# Waterline FEIS Addendum – Meliadine Mine

*Technical Comment Responses*

Submitted to:  
**Nunavut Impact Review Board**

Submitted by:  
**Agnico Eagle Mines Limited – Meliadine Division**

**Figure ECCC-TRC-01: Percentage of Maximum Salinity Change throughout the Water Column at the Edge of the Mixing Zone for the Low Salinity Effluent Scenario**

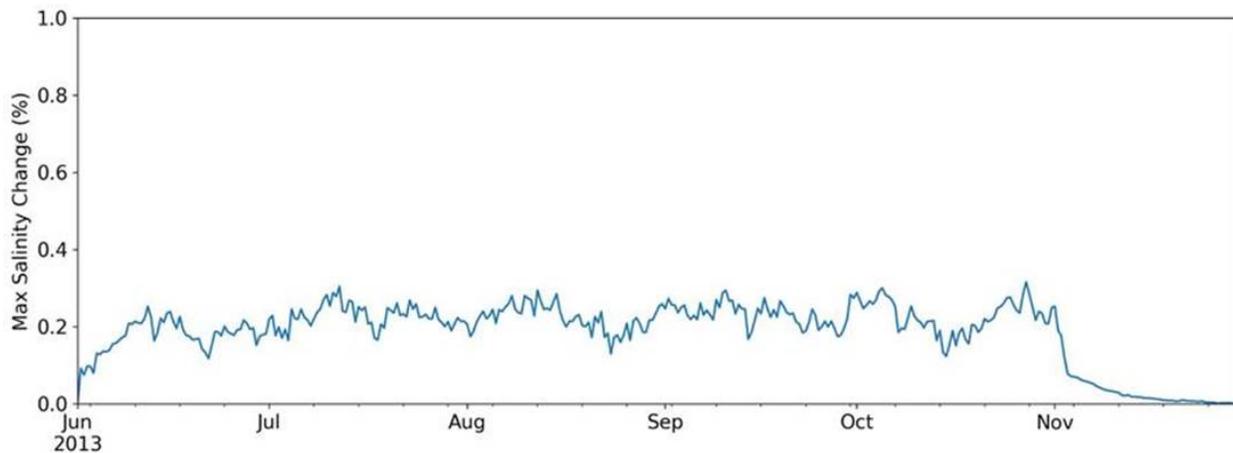
*a) add invertebrate sampling as a monitoring objective of the ODMP.*

Results of hydrodynamic modelling conducted for the Project suggest that effluent salinity will be less than 1% by 100 m from the discharge point under the scenarios of high salinity effluent (i.e., 39.6 PSU [Practical Salinity Unit]; Tetra Tech 2020) and low salinity effluent (i.e., 14.9 PSU; Attachment TC-02) and as summarized in Table ECCC-TRC-01a. The low salinity effluent simulation presented results with slightly higher concentrations at the edge of the mixing zone compared to the high salinity effluent simulations. Therefore, Figure ECCC-TRC-01 presents the results corresponding to the low salinity effluent simulation: the percentage of maximum salinity change throughout the water column and at the edge of the mixing zone was calculated for the entire open-water season. The maximum salinity change reaches about 0.3%, and is well below the 1%.

In absolute values, since the ambient ocean salinity ranges between 30 and 32 PSU in the vicinity of the diffuser, a 1% change corresponds to a value of 0.3 PSU, which is never reached, as shown in Tetra Tech (2020) Figure 5.15 and Attachment TC-02 Figure 3.8.
